## TUALATIN CITY PLANNING COMMISSION MEETING

THURSDAY, JANUARY 21, 2021

1. The Tualatin Planning Commission is asked to provide a recommendation to the City Council on adopting an updated Stormwater Master Plan for the City of Tualatin and updating Comprehensive Plan policies and relevant Development Code references to reflect the updated plan (Plan Text Amendment PTA 21-0001).

Exhibit 5 – Public Comments on Stormwater Master Plan 12-7-20 through 1-10-21

**Figure 12.** County Existing Plan Drawings with Annotations Highlighting the IMPLENTED Piping Conditions

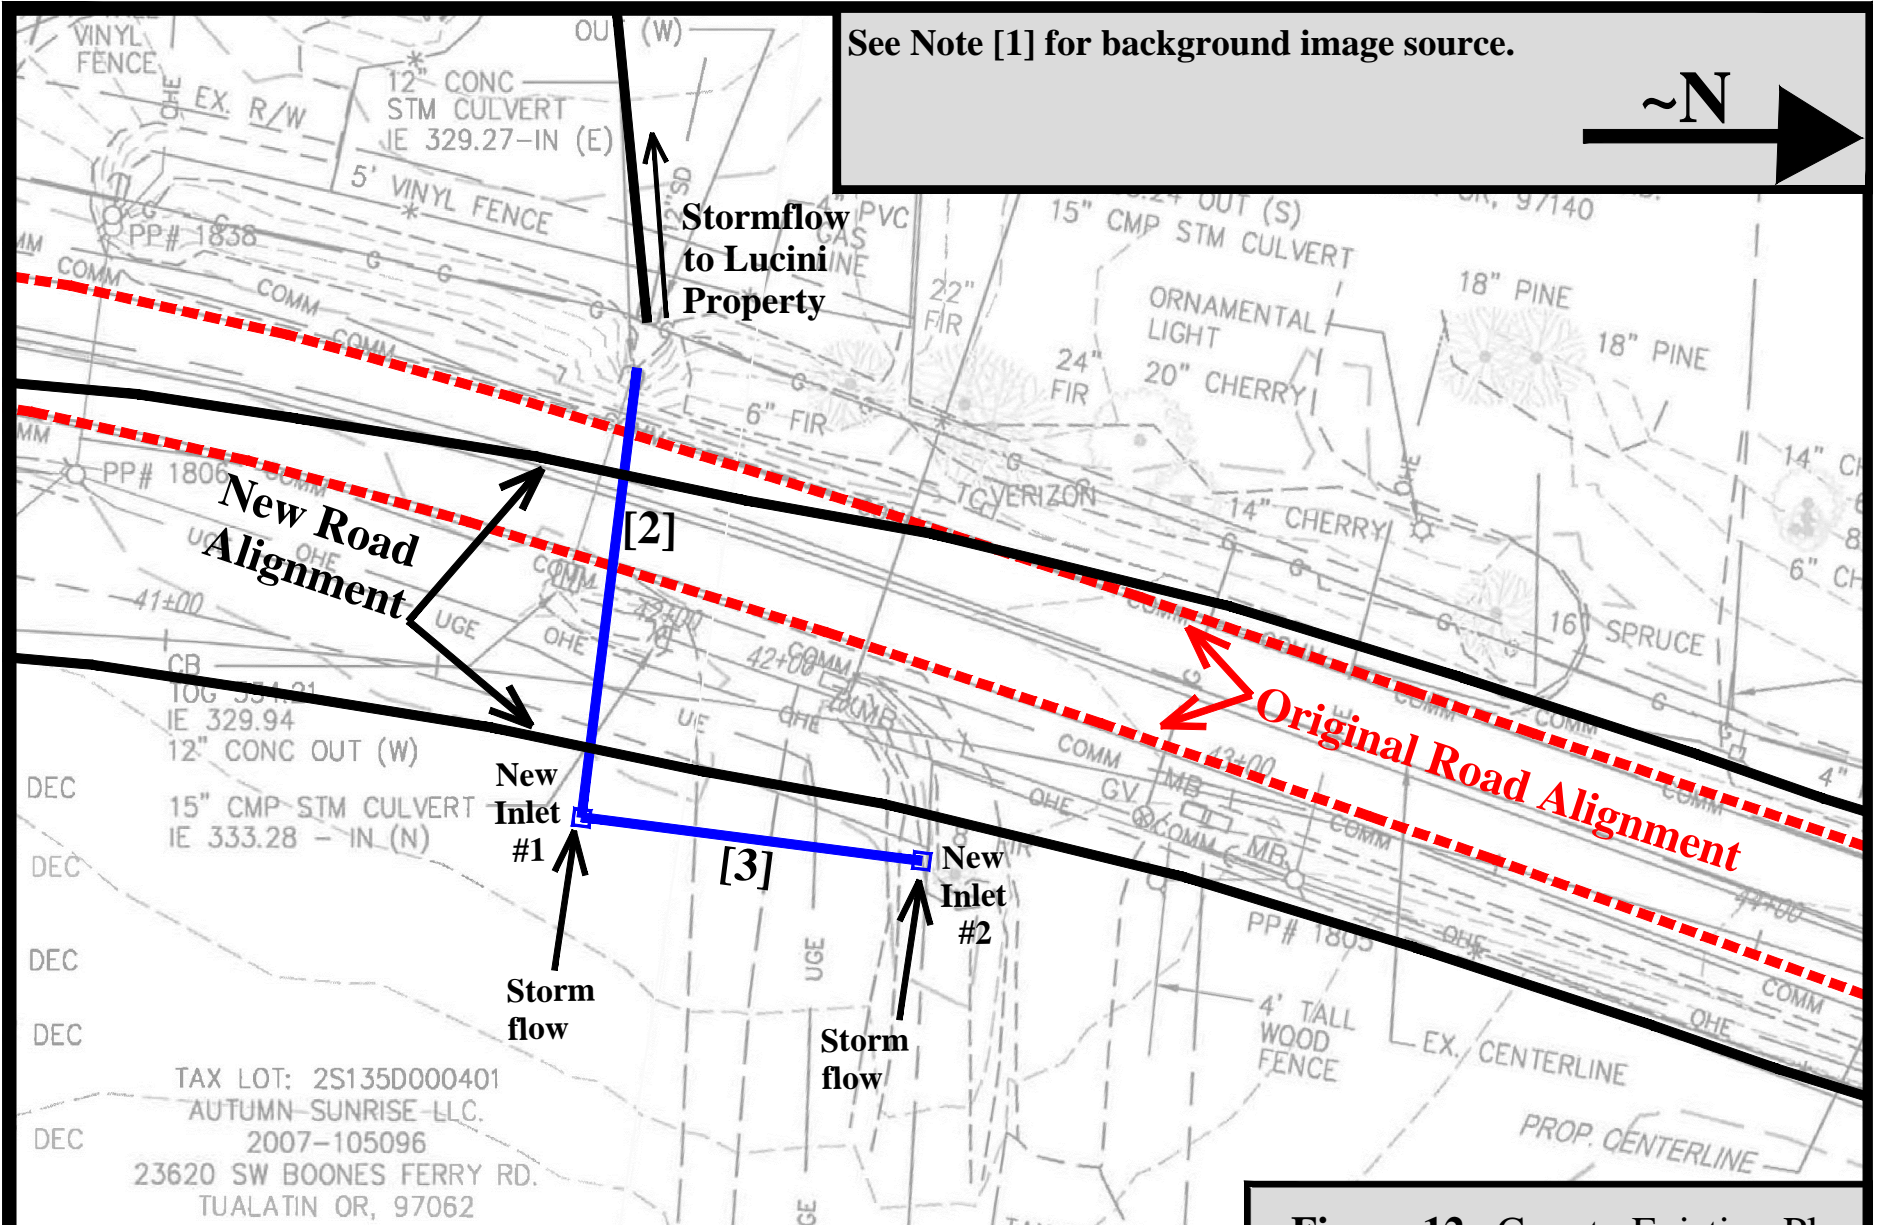
Figure 11 shows the hydraulic conditions for connecting piping and the original road culvert locations for the ORIGINAL configuration. Figure 12 illustrates the IMPLEMENTED hydraulic conditions consisting of connecting piping and the new culvert comprising the County's Outfall #5. Figure 12 also shows the juxtaposition of the old and new Boones Ferry Road that hydraulically affects flows to the Lucini property.

The County provided storm grates on its two new stormwater inlets in the subbasin above the Lucini property as shown in Figure 12. The County neglected to provide a storm grate for the pipe entrance to the Lucini property (see Figure 12). The Lucini property drainage receives stormwater passing through SW Boones Ferry Road culvert (Outfall #5). The County supposed that its generated stormflow will be conveyed successfully through the Lucini property. The Corps HEC-HMS and HEC-RAS demonstrate that this is not the case for the 25-year design storm cases presented in this analysis.

An orifice plate can be used to reduce storm pipe flow diameter and flow area during peak flow events. This physical measure decreases peak stormflows and lowers storm flow velocities on the Lucini property. The location of the proposed orifice plate is shown in Figure 12 as indicated in the IMPLEMENTED new storm inlet #1.

The County has indicated it is using CWS 2007 for guidance, which contains: Drawing No. 270 “Flow Control Structure Detail” that can be installed at the New Inlet #1 location; and Drawing No. 240 “Water Quality Manhole (Mechanical)” that can be installed just upstream of the Lucini property pipe entrance. For convenience, CWS Drawing Nos. 270 and 240 are contained in Appendix G of this report. See Figure 12 for the locations of these proposed flow and water quality control facilities.
